RE: UM 1910 – PacifiCorp’s Resource Value of Solar – ERRATA FILING

PacifiCorp d/b/a Pacific Power encloses for filing the corrected testimony of Daniel J. MacNeil (PAC/100). For convenience, both a red-line and clean version of the complete testimony are enclosed.

ERRATA

Exhibit PAC/100

1 **Figure 4: RVOS Avoided Energy Cost for the Indicative Fixed Solar Resource**

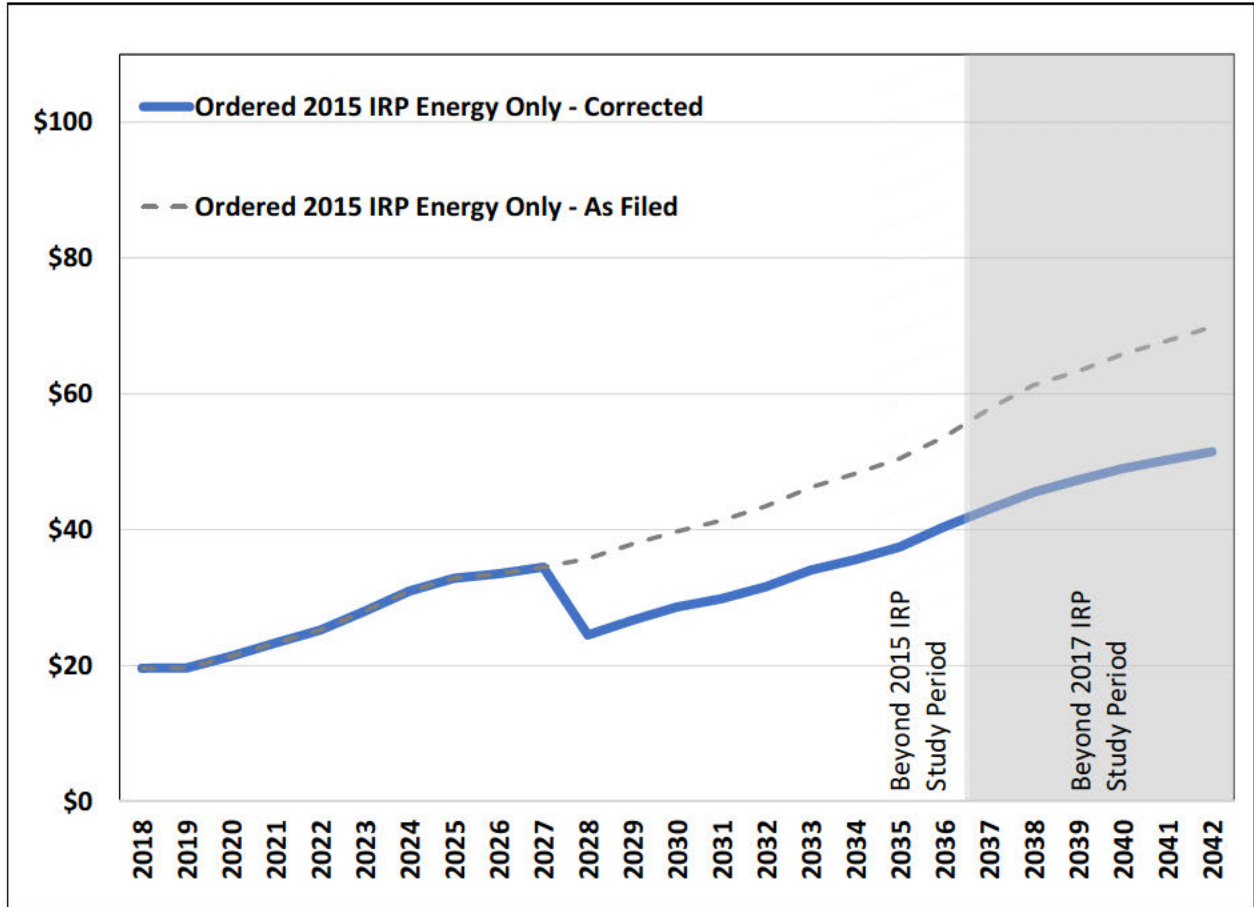
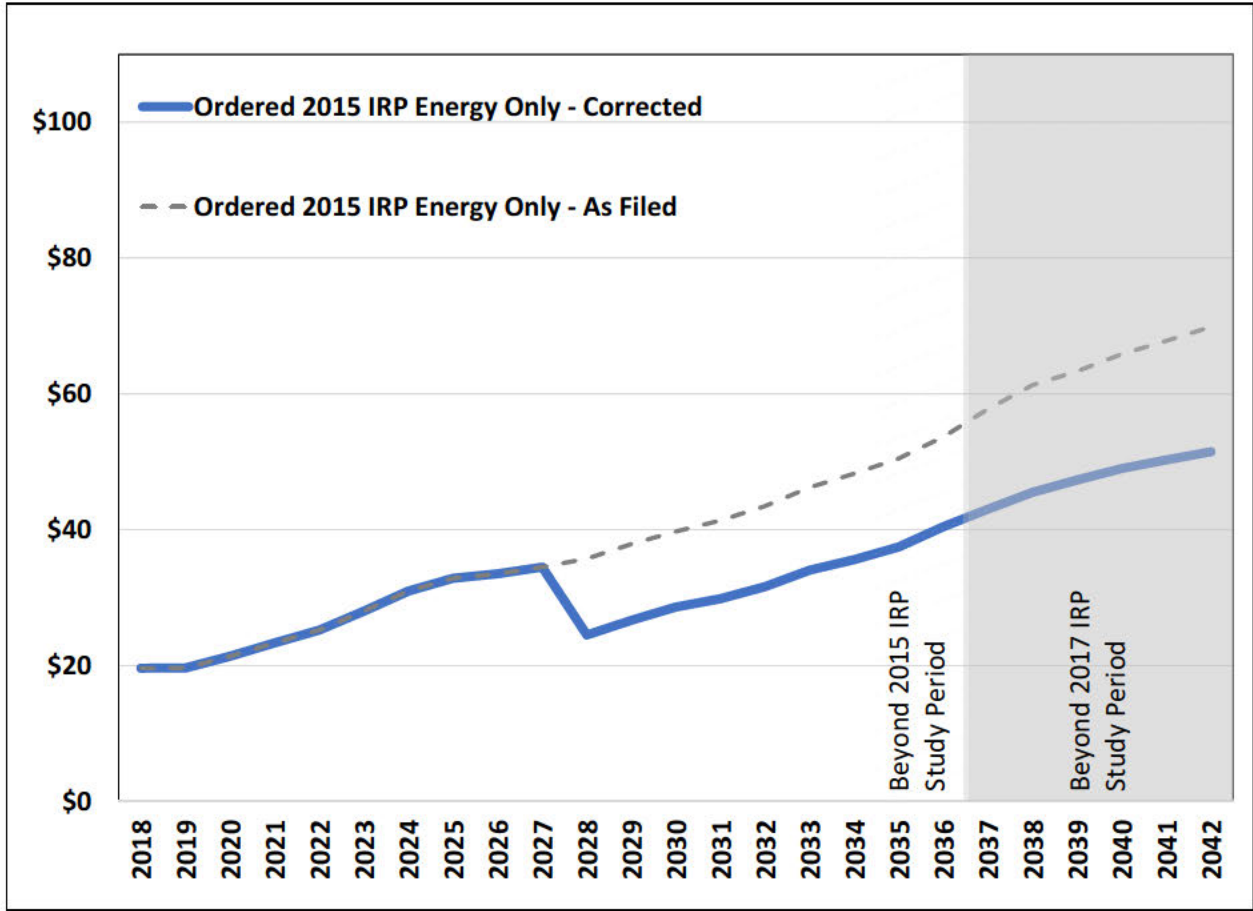
- Page MacNeil/3 – corrected Table 1 – Standard 2015 IRP column
- Page MacNeil/18 – corrected Figure 4
- Page MacNeil/35 – line 13
- Page MacNeil/46 – line 22 through MacNeil/47 – line 10
- Page MacNeil/48 – corrected Figure 5
- Page MacNeil/49 – line 4
- Page MacNeil/49 – corrected Figure 6
